Re: Duggers Towing

7001 San Pedro NE

Re: Duggers Towing, Grading and Drainage Plan
Engineer's Stamp Date 04-02-2013 (D-18/D034)

Re: Revised Drawing - Duggers Towing, Grading and Drainage Plan, Engineer's Stamp Date 04-02-2013 (D-18/D034)

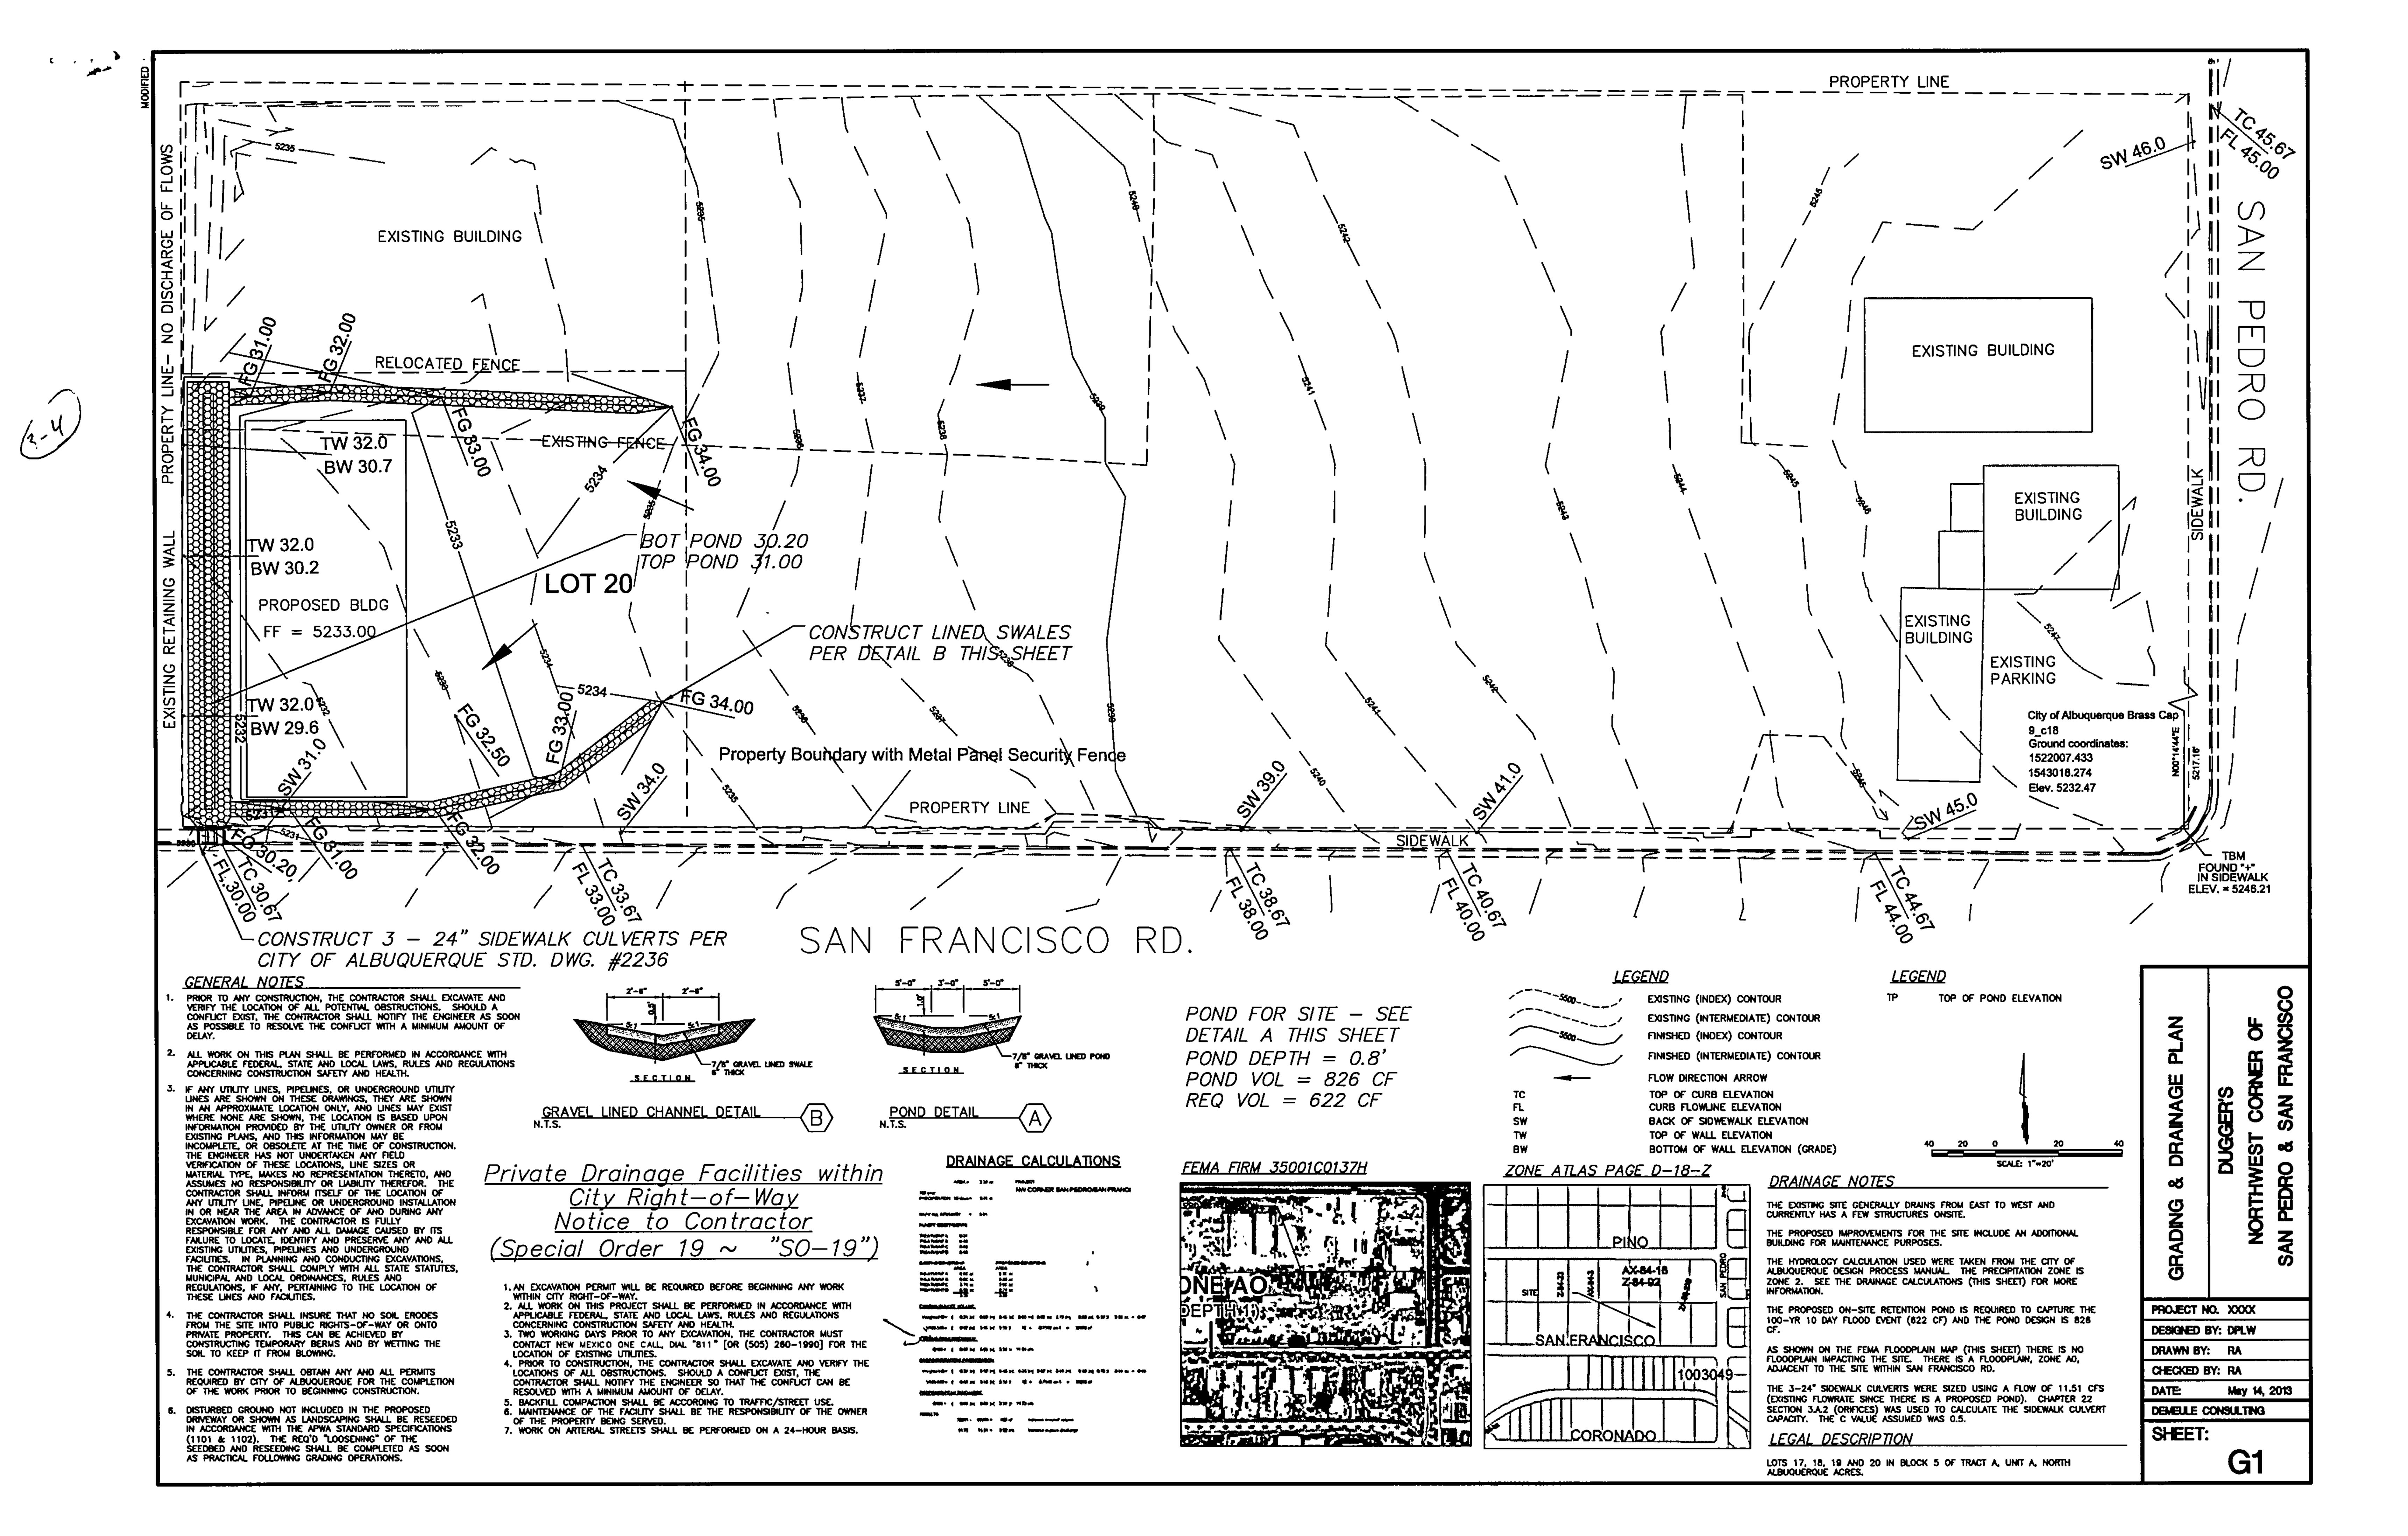
I look at the plan and had the following comments:

- _ower the pond so we would retain the developed volume. The invert of the sidewalk culverts and the bottom of the pond are the same elevation.
- 2 Change the property line to a thicker solid line or phantom for clarification.

- 3 Extend the sidewalk culvert 2' passed the property line. Add a note to the sidewalk culverts to "TACK WELD THE BOLTS AT THE PLATE".
- 4_ Provide sidewalk culvert capacity calculation.

- 5 Increase the txt size for the drainage calculations on the plan.
- 6_ Can you redesign the pond to make it a retention/detention pond to limit the discharge so you would only need 2-2' sidewalk culverts? Possibly the top of the pond would be at 31.50 or 32.00 and the bottom may at 29.20 and discharge point at 30.20. Provide a headerwall at the back of the inlet (with the top at 31.5 or 32.0) and opening sized to the sidewalk culvert dimensions.

Let me know if you think his plan will be sufficient. He has added 3 - 24" culverts as well as the SO-19 standard notes. He will need to add the note to tack weld the bolts and to extend the culvert.

The drawing has been revised with the additional information you requested:

Sidewalk culverts

Additional spots and grading showing flowpaths into the swales

Additional spots near the pond and back wall

Datum reference (benchmark)

We have been unable to have the surveyor gain access to the private property along the back wall, but have added the top of wall information and bottom of wall. the proposed top of pond is approximately 1 foot lower than the top of retaining wall on the Duggers site, and the proposed sidewalk culverts will provide positive drainage to the curb and gutter prior to flows topping the back wall.

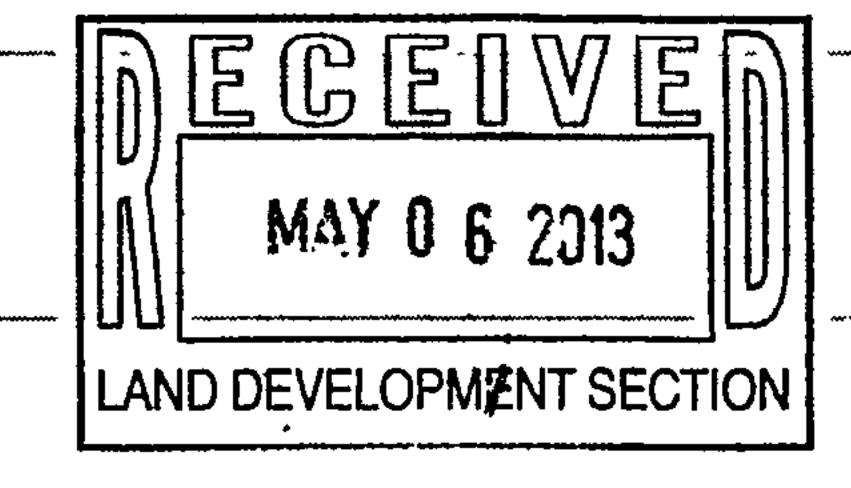
Provide additional spot elevations of the site interior as well as extend contours and show additional spots to the west of the property.

More detailed contouring is shown in the revised drawing, as well as extended contours and spots to the west. (Private property access was not granted to the west, but we have provided spot elevations where we were able to legally acquire topography)
